CHANGE ORDER NO 10 SUMMARY REPORT

PALM BEACH INTERNATIONAL AIRPORT
LONT TERM PARKING GARAGE NO 2

**RE: Review of JAC Cost Proposals Associated With Change Order No. 10 -
28KR1, Modification of Above Grade Plumbing
28BR1, Modification of Underground Plumbing
28MR1, Modification of Storm Drainage System
28JR1, Modification of Water Main System**

CHANGE ORDER NO: **Ten (10)**
 COUNTY/FAA PROJECT NO: **PB 05-3**
 CONTRACT DATE: **5/16/2006**
 RESOLUTION NO. **R2006-0842**
 DISTRICT # **2**

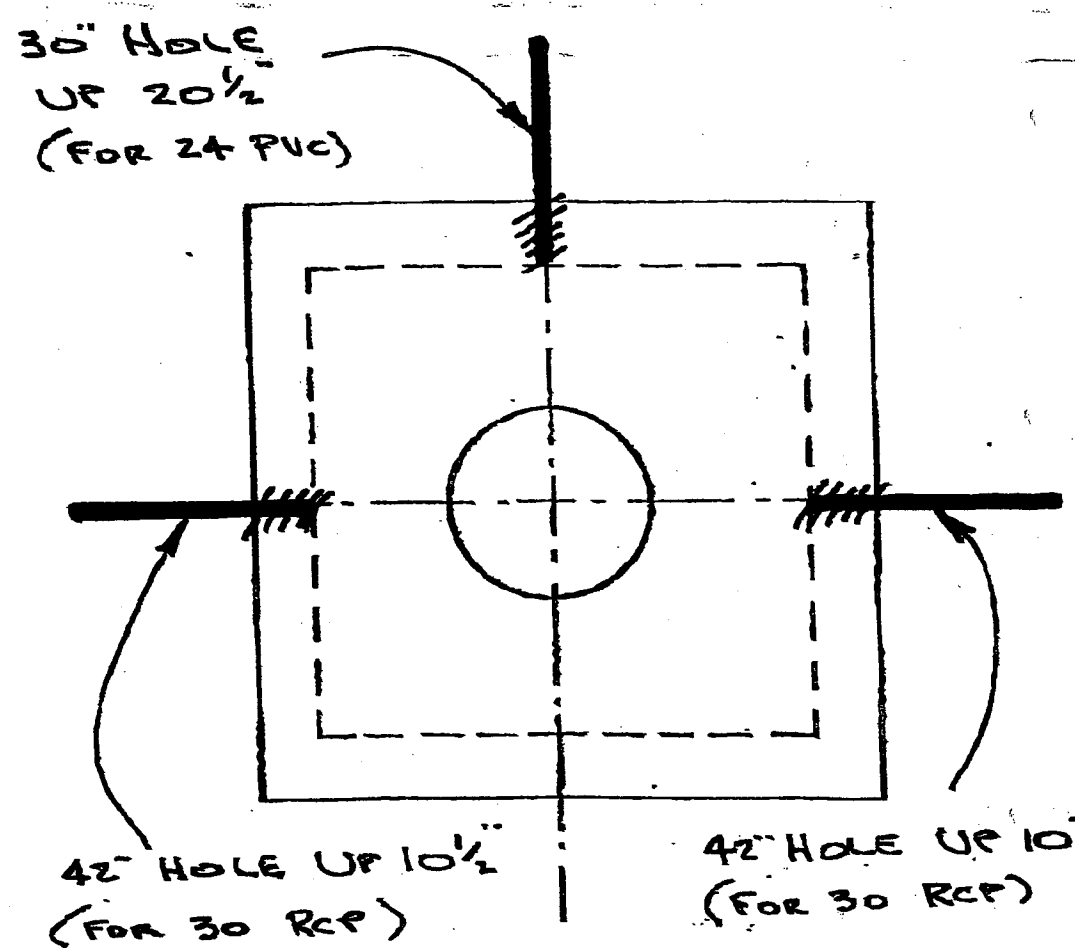
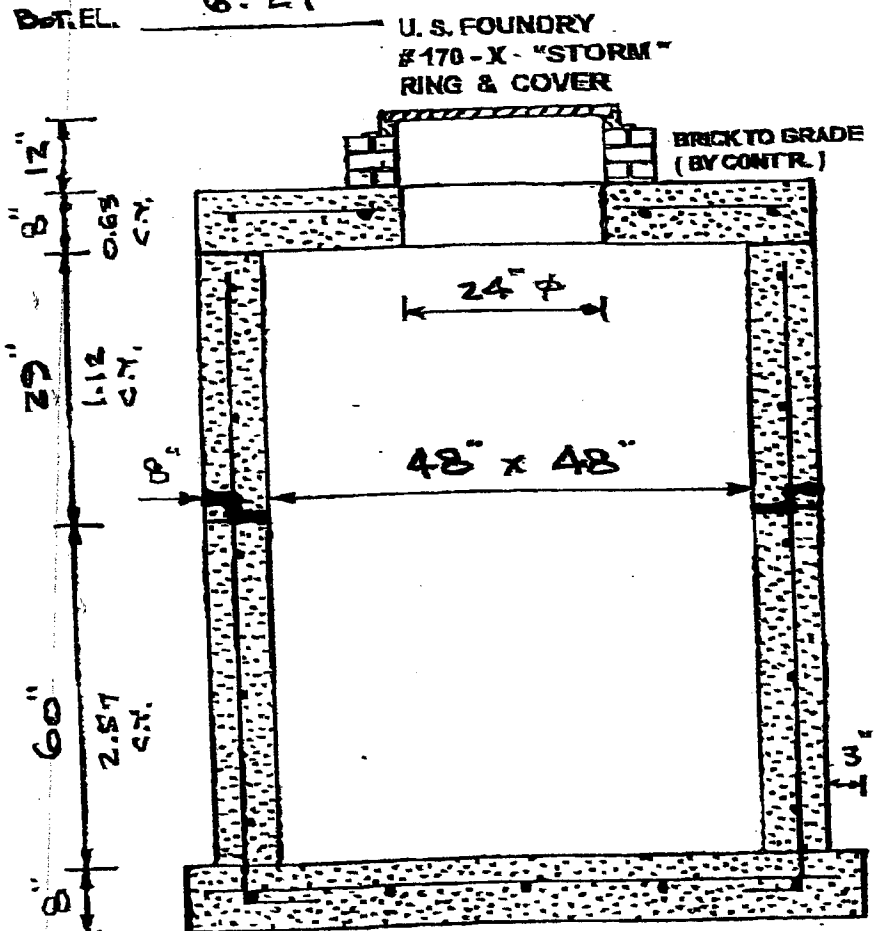
- 1 Existing Structures SD9 & SD10 have bottom elevations of 10.8. These structures will be left in place to act as yard drains. New pipe run will bypass these structures and tie directly into SD5 & SD8 respectively.
- 2 Floor Drain pipes will be run from existing structures SD 5, & SD 6, and a n additional SD 7A to within 8" of Building at the locations as depicted on the plumbing drawing.
- 3 Mobilization costs is charged for west connections only.

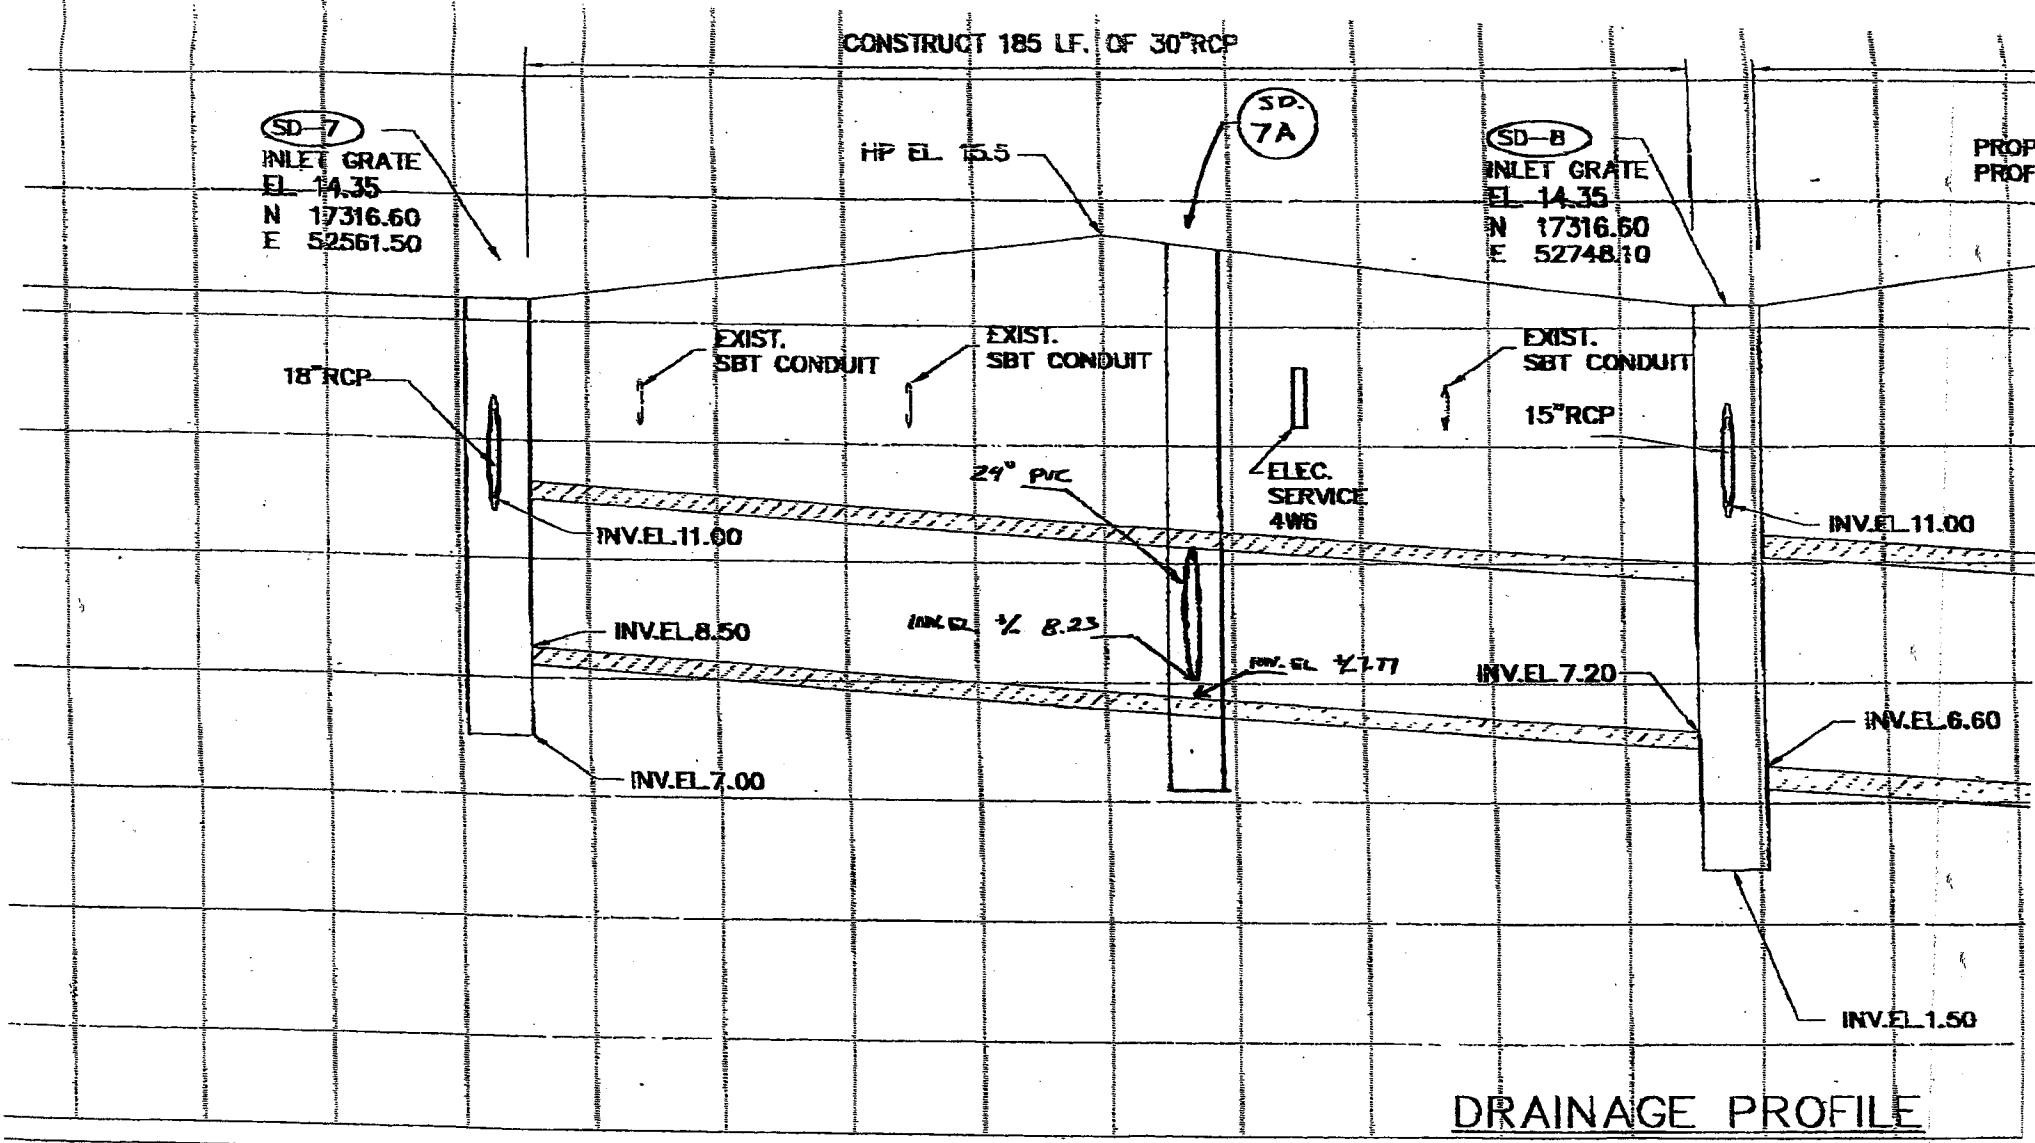
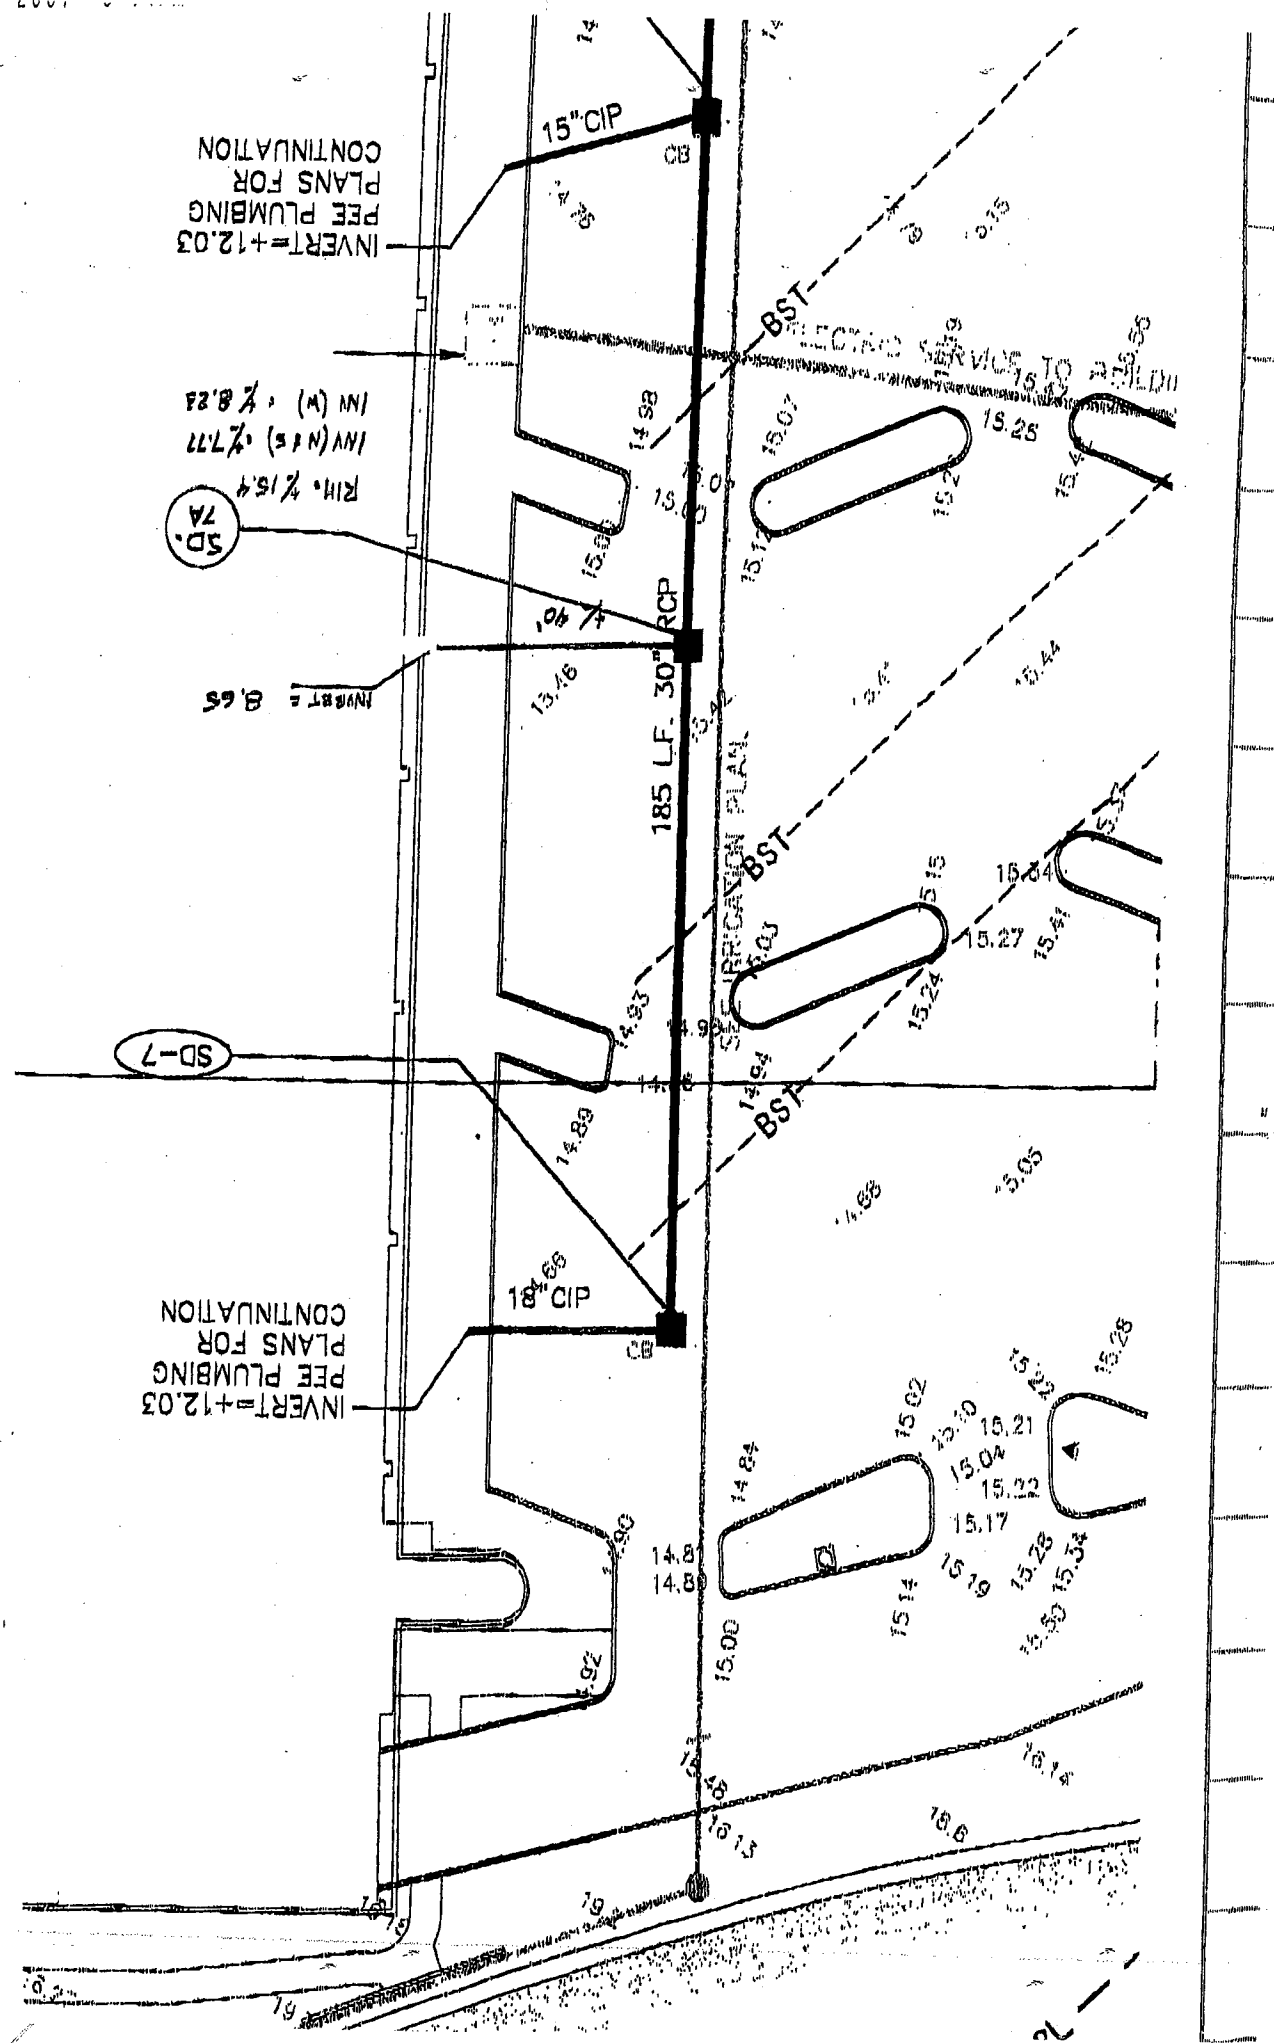
Description of change: MATERIAL, LABOR, EXCAVATION, DE-WATERING TO INSTALL NEW DESIGN UNDER GROUND STORM PIPING TO CORRECT ELEVATION PROBLEMS AT DRAINS. MAIN EAST TRUNK LINE IS NOW PVC DUE TO INCREASE IN PIPE DIAMETER. DE-WATERING SYSTEM, TRENCH BOX AND LABOR TO MAINTAIN SYSTEM NOT IN ORIGINAL SCOPE.
